M2-20100221-01

Re: M2 Widening Project - Cycling Route February Response

Concept Issues Involved in the Planning of the Alternate Cycle Route

Specific issues to be resolved in design of the Alternate Cycling Route.

Path along Roselea Park

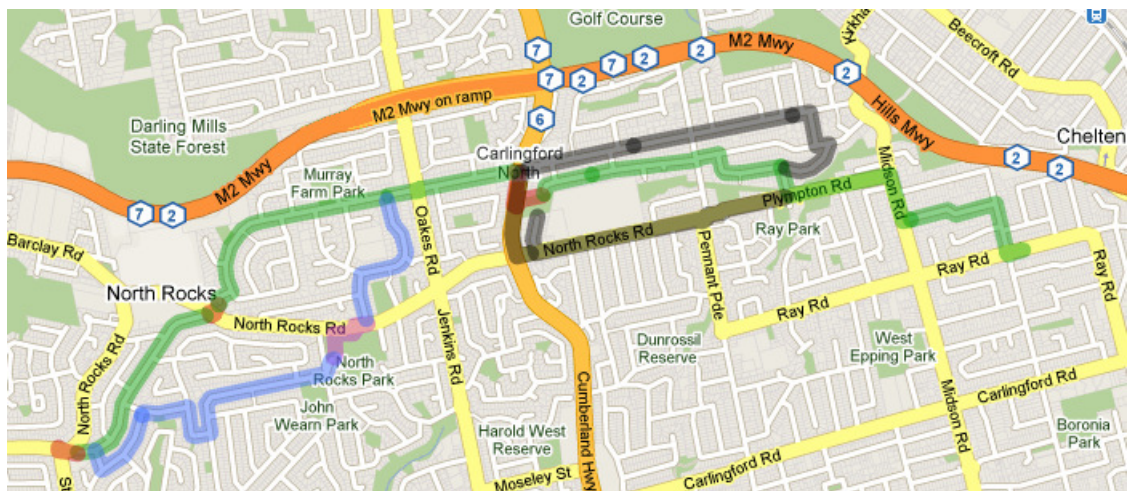
- a) The report proposes changes in this area using back streets to avoid traffic pressure, but adding significantly to distance, hills and stoppages. An off road path is proposed along the northern side of Roselea Park to an existing pedestrian crossing then an off road path along past three busy commercial premises with significant driveway crossing risks. Then to use Murray Farm Road with traffic and a significant eastbound hill. Some steep back street sections, a small inappropriate lane with a corner, poor surface, hill ends on a main

footpath. The route then takes the wide New North Rocks Road past the shopping centre with pedestrian crossings and squeeze points.

Route options in the Beecroft-North Rocks area for consultation

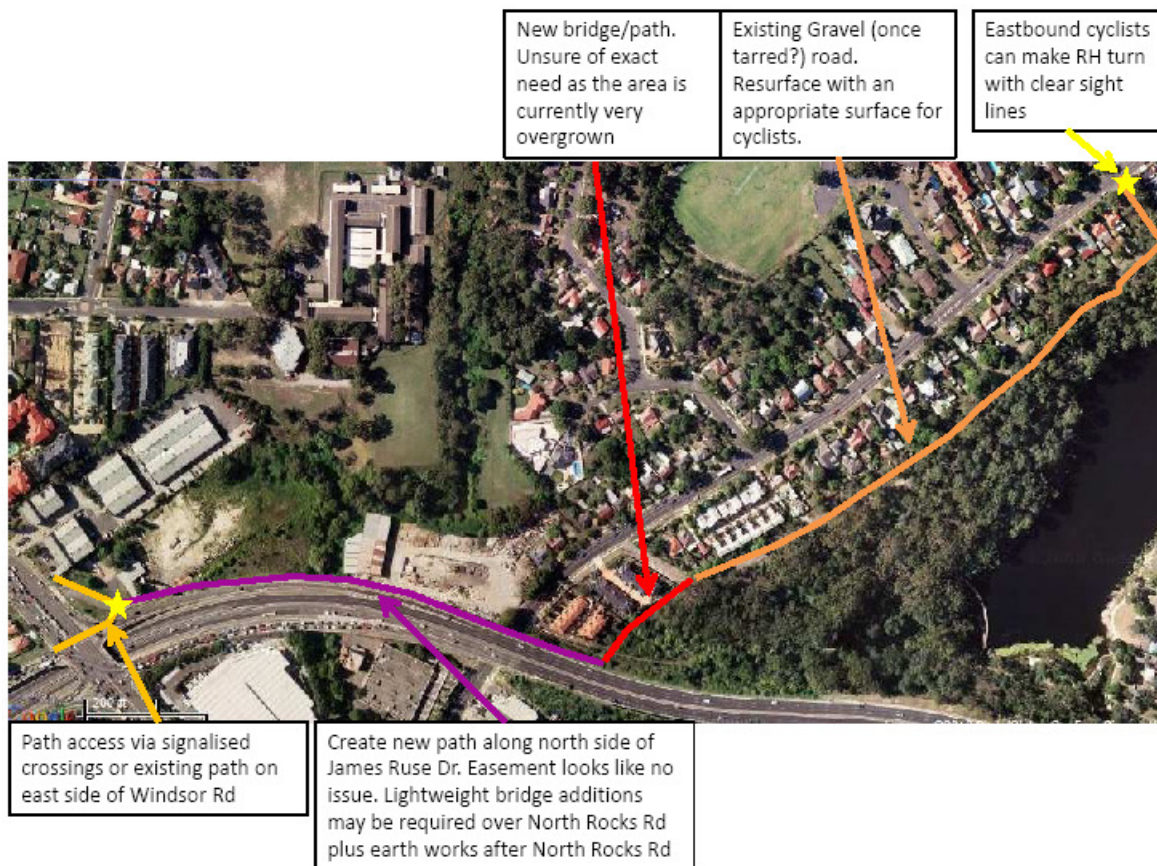
Bus stop and businesses on PH Rd

Long steep hill on Murray Farm

Narrow, steep lane with corner

- b) Other route options may be considered in this area including other back streets, using Pennant Hills Road on road for a short section. There is no good solution and it may be that a number of options are provided as conditions vary through the day and week. Further consultation is required on the detailed design and route approval.
- 5) North Rocks Road to Windsor Road area
- a) In this difficult situation even the report does not have a firm proposal. Emphasis must be on safety and minimal delay. We believe that a good option is a wide overbridge across Windsor Road bridging from Boundary Road to North Rocks Road.
 - b) An alternate solution is to turn east along the north side of Cumberland Highway on a new high quality off road path, fly over North Rocks road on a clip-on bridge then turn north behind the houses along the old road easement.
